NL-04-2459

Vogtle Electric Generating Plant  
10 CFR 21 Report  
Electric Power Research Institute  
Motor Operated Valve Performance Prediction Methodology  
Versions 1.0 through 3.2

## **PPM Software Error Notice 2004-2 (Potential Non-Conservatism in Butterfly Valve Model Predictions under Compressible Flow Conditions)**

**Figure 2 (Cont.)**  
**Butterfly Valve Disc Shapes (shown to scale) Used in Compressible**  
**Flow Tests Performed by Kalsi Engineering, Inc.**

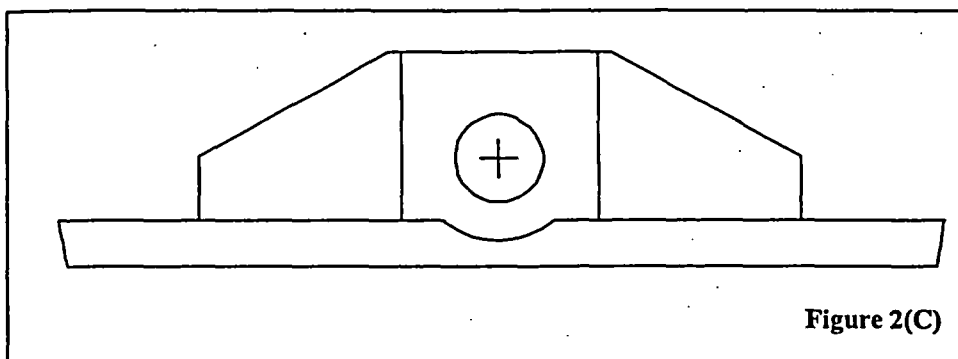
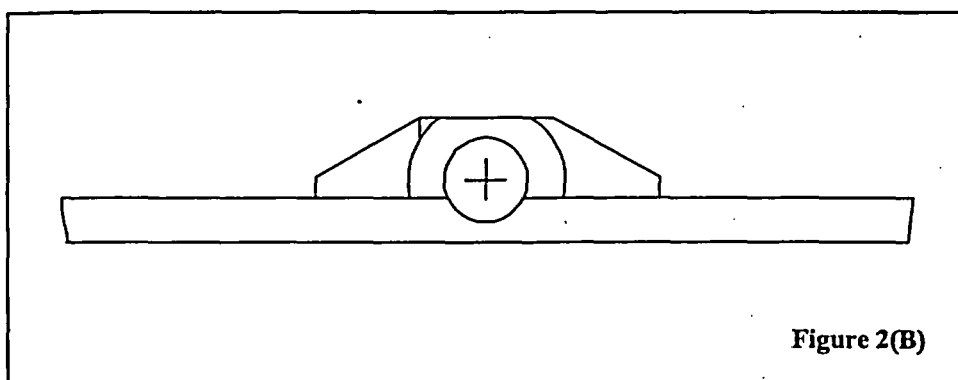
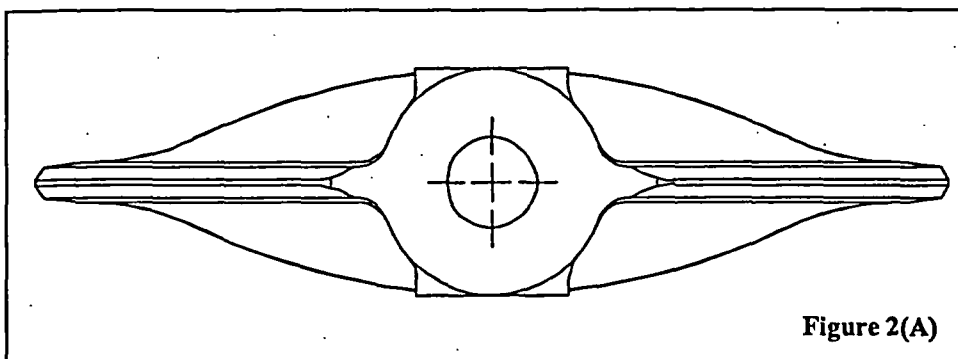
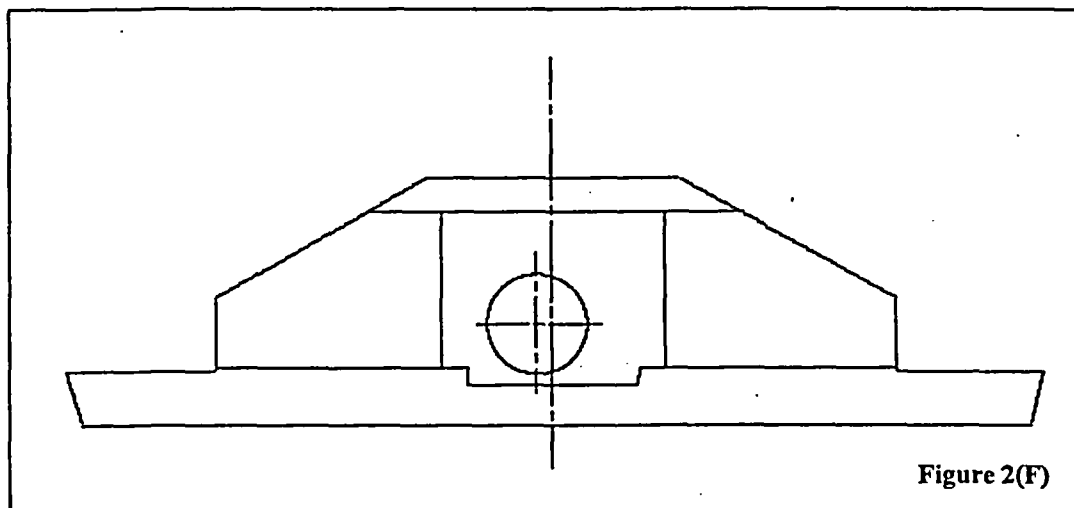
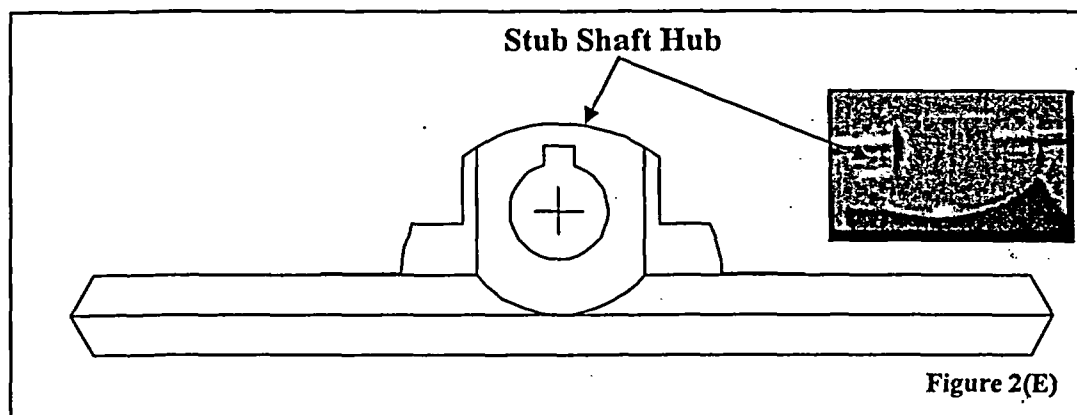
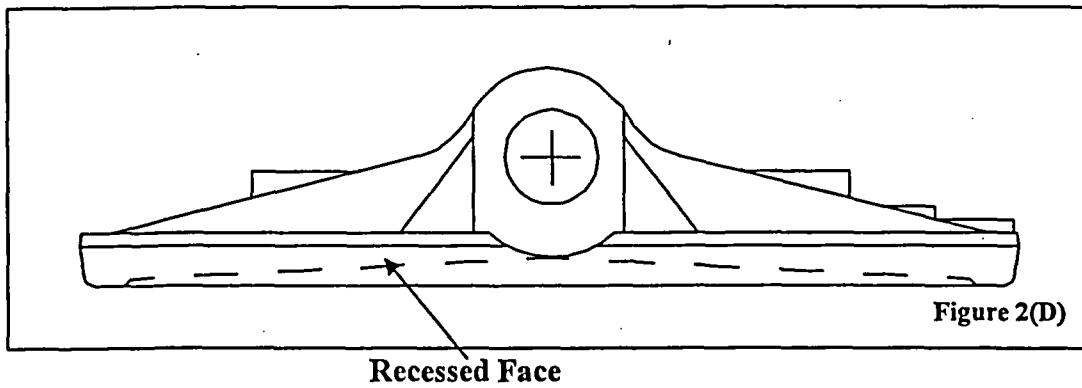
Comparisons completed to date show that under compressible flow conditions, the PPM butterfly valve predictions of maximum required hydrodynamic torque in the closing direction for the disc design shown in Figures 2(C) and 2(D) were found to be non-conservative by as much as 5 percent and 45 percent, respectively. The disc design shown in Figure 2(C) has similar geometric features to those tested by INEL. The disc design shown in Figure 2(D) is somewhat different than the INEL test valves disc shapes used to validate the PPM for compressible flow conditions, in that it has a shallow concave recess in the front face. The reported non-conservatism in hydrodynamic torque is based on limited comparisons between the PPM predictions and test data. Under compressible flow blowdown conditions, the hydrodynamic torque is the major component of the total required dynamic torque that is used for actuator sizing

Table 1 shows the applicability criteria for the PPM Butterfly Valve Model (Reference 1, page 7-24). The Table indicates applicable disk designs must have prismatic or conical back faces and flat front faces. The disk shown in Figure 2(C) is clearly applicable for PPM evaluations based on these criteria. The disk shown in Figure 2(D) has a shallow concave recess in the front face. Reference 2, page 2-1, under Terminology: Non-symmetric disk with single offset stem states, "The disk face away from the stem is typically flat or has a small curvature and is commonly referred to as the flat face". Based on this statement, the shallow concavity of the disc shown in Figure 2 (D) can be interpreted to be within the applicability of the PPM. Table 1 also indicates that the disc must have a prismatic or conical back face. The disc shown Figure 2(D) has features that could be interpreted as being prismatic and therefore within the applicability of the PPM.

1. Pending further EPRI evaluation, for butterfly valves with non-symmetric discs with the shaft in the downstream orientation, in compressible flow applications and in the closing direction, use of the PPM Butterfly Valve Model should be restricted to valves with a completely flat front face, e.g., the PPM butterfly model shall not be applied to butterfly valves with a recessed (curved or flat) front face.

1. For butterfly valves with non-symmetric discs with the shaft in the downstream orientation, in compressible flow applications and in the closing direction, meeting all PPM applicability requirements and accounting for the restriction described above, the predicted maximum required total dynamic torque shall be multiplied by 1.05.

- If the front face is recessed, the user should evaluate the potential impact of a 45 percent increase in the maximum total required dynamic torque prediction.
- If the front face is truly flat and is not recessed, the user should evaluate the potential impact of a 5 percent increase in the maximum total required dynamic torque prediction.
